SERVICE BULLETIN

from: TRIO-KENWOOD COMMUNICATIONS, INC.

SUBJECT: TS-180S DFC HUM WITH PS-30

SUBJECT: TS-180S IF OUTPUT #2 LEVEL CHANGE FOR SM-220 OPERATION

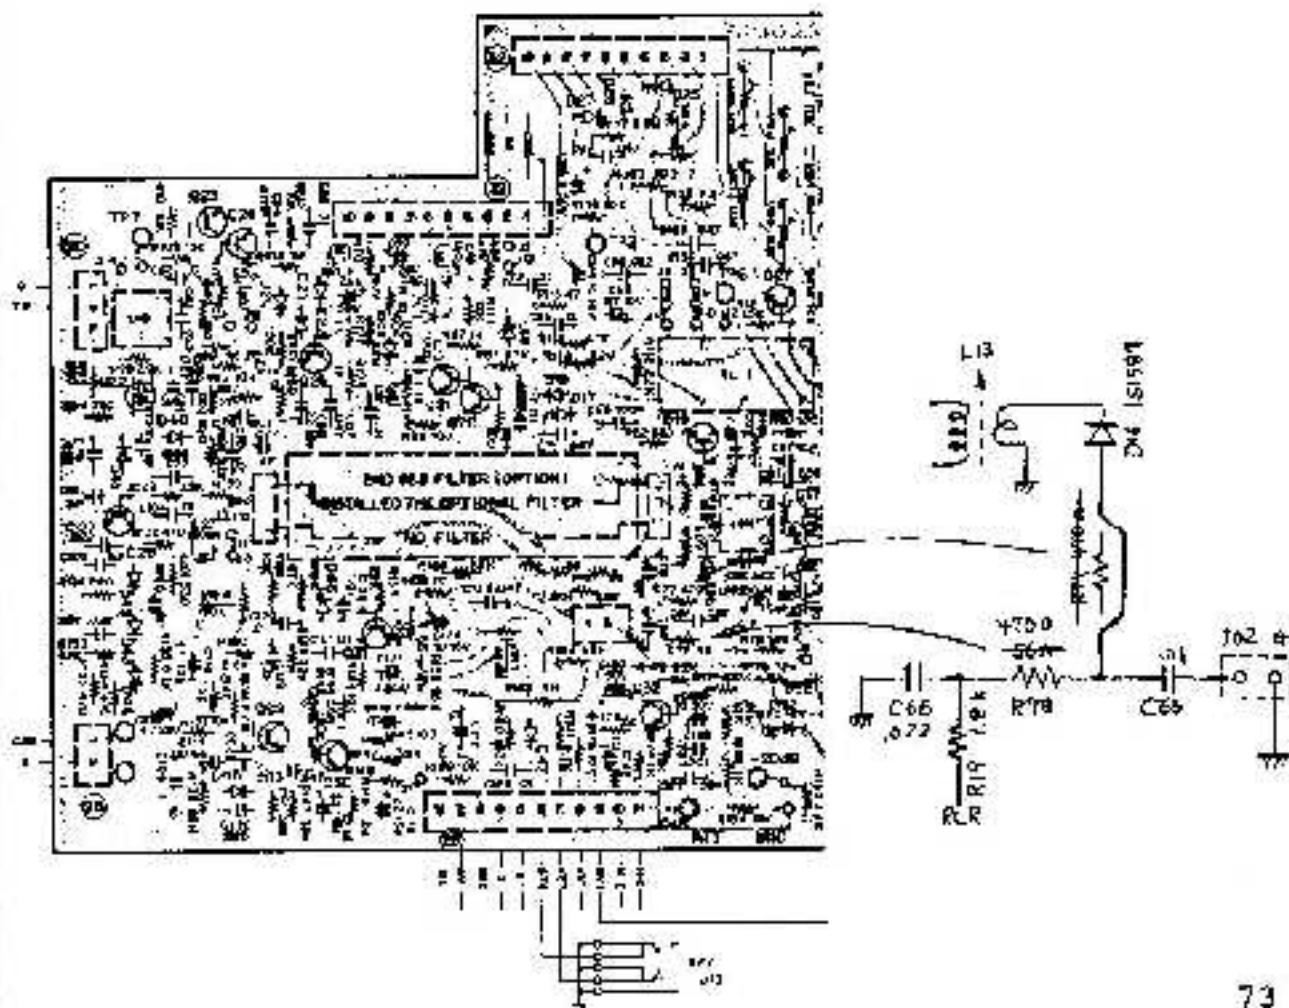
TS-180S owners who desire to operate an SM-220 for IF output display will require a wiring change to the IF unit X48-1240-00. No additional parts and no adjustments are required.

Remove R77, 470 ohm, and replace with wire jumper. Remove R78, 56 ohm, and replace with old R77. The 56 ohm resistor is not used.

With AGC on, gain should be adequate for about a 3/4 screen display.

SUBJECT: TS-180S INCREASE OF RX AUDIO OUTPUT

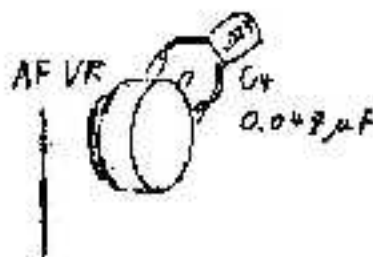
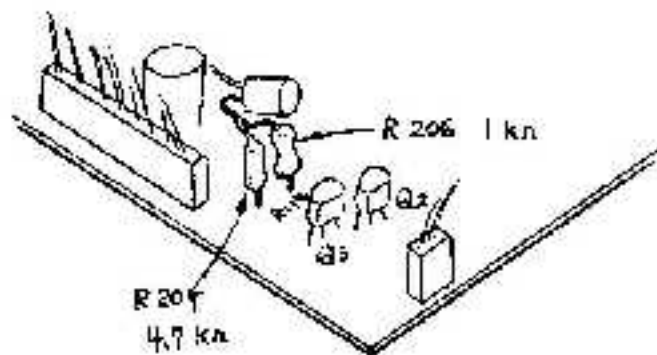
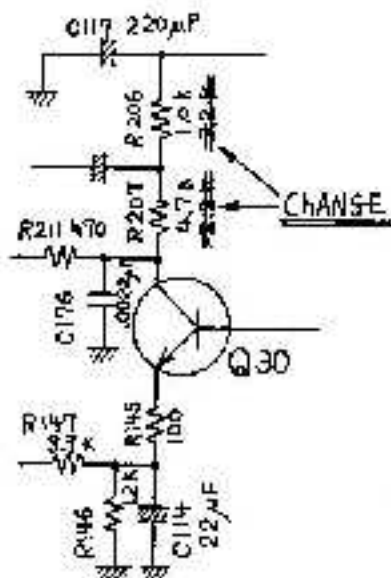
RX audio output from the TS-180S may be increased a total of 4.7 dB. This is an optional change which you can make at the owners request.

On the IF unit X48-1240-00 change components:

R206 2.2K change to 1 K ohm

R207 2.2K change to 4.7 K ohm

On the AF Gain Control, between pin 1 and 3;

C4 .047uF change to .027uF mylar

▼ LPF UNIT (X51-1180-00)

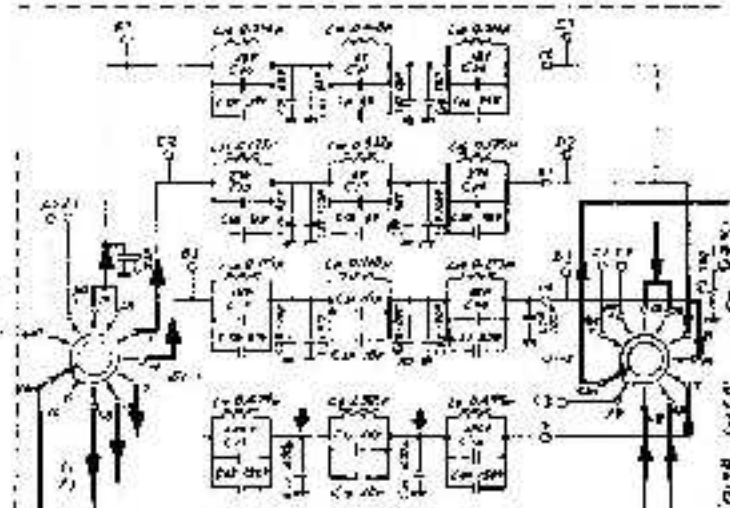
Some operators may experience intermittent reduction or loss of ALC, especially after several minutes transmit time.

On the LPF unit X51-1180-00, change C14, C17 from 470 pF to 390 pF. Check ALC level and adjust if necessary, per section 406 ALC meter adjustmet, TS-180S service Manual.

New part: CM93D2H390J 390pF +/- 5% 500v mica or ceramic

SUBJECT: TS-180S DFC

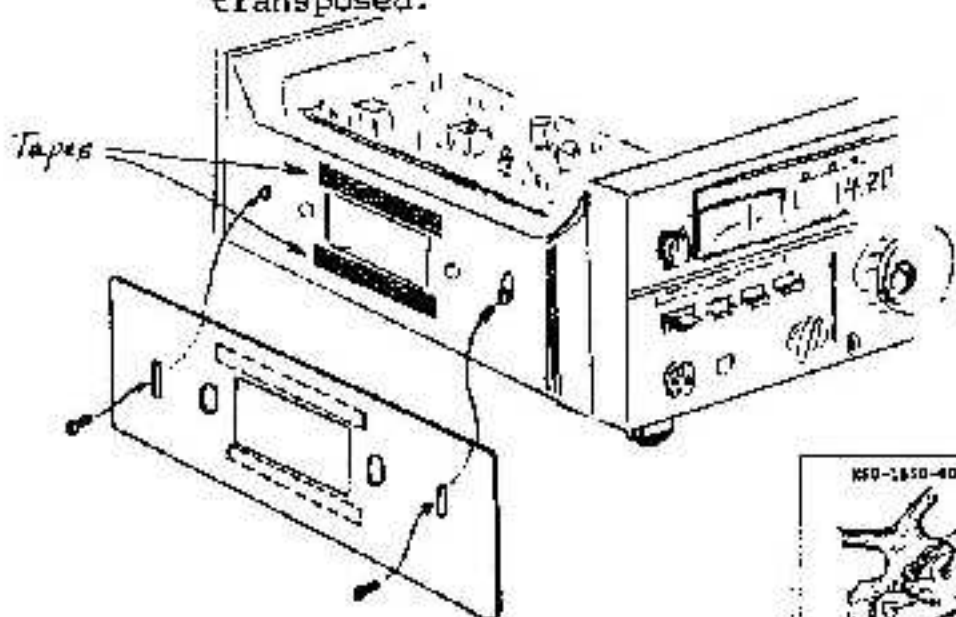
For complaints of either induced power supply hum, or intermittent frequency stability while using the DFC, perform the following changes to the VCO unit X50-1550-00:

- *1. Install a 330K ohm resistor between Q11 G1 & the 8V line. Connect from L7 at C12 to Q11 G1, at R35.
- *2. Replace L12 68uH with new part L40-6831-21.
- *3. Replace L13 150uH with new part L40-1541-27.
- *4. Install magnetic shield as illustrated. Use the two existing screws, plus double faced tape to prevent vibration.

Note: On page 37 of the Service Manual, the VCO Board view shows reversed callouts for Q11 & Q15. D & S, and G1 & G2 are transposed.

SUBJECT: TS-180 VFO STABILITY

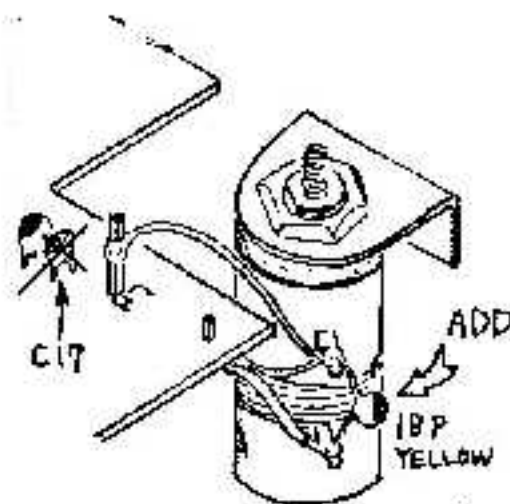
VFO drift characteristics may be improved by changing a capacitor value and location in the VFO.

3. Withdraw out the front panel and unplug the leads.
4. Remove the VFO cover by five Phillips head screws.
5. Remove C17 from the PCB. This may be cut flush to the board.

6. Install the 18 pF yellow cap across the tank coil terminals. Position the cap near the coil.
7. To reassemble, performs steps 3, 2. Snug all VFO case screws. A later complaint of frequency jump would indicate a loose VFO shell.

New Part: 18pF CC45RG1H180J
Old Part: 18pF CC45PG1H180J

SUBJECT: TS-180S DFC INSTABILITY

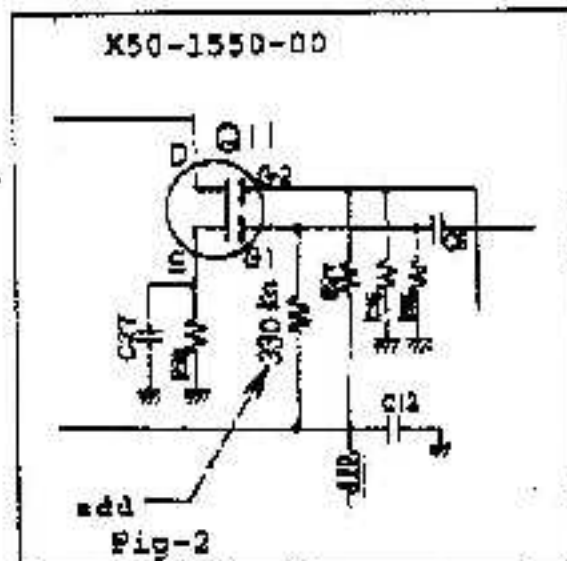
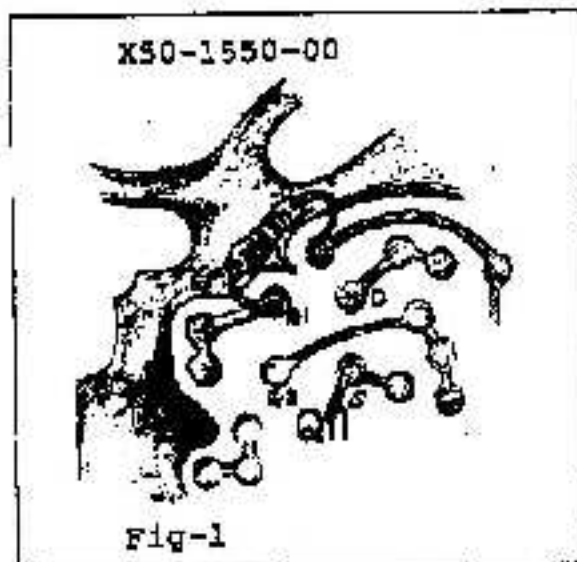
TS-180S operators may report intermittent DFC instability, especially at 10Khz even points. This may be characterized in some cases as PM'ing.

On the VCO unit X50-1550-00, install a 330K ohm resistor between Q11 G1, and the 8V line. Connect from L7 at C12 to Q11 G1, at R35.

On page 37 of the Service Manual, the Board view of the VCO unit contains reversed callouts for Q11 & Q15 FET's. D & S, and G1 & G2 are transposed.
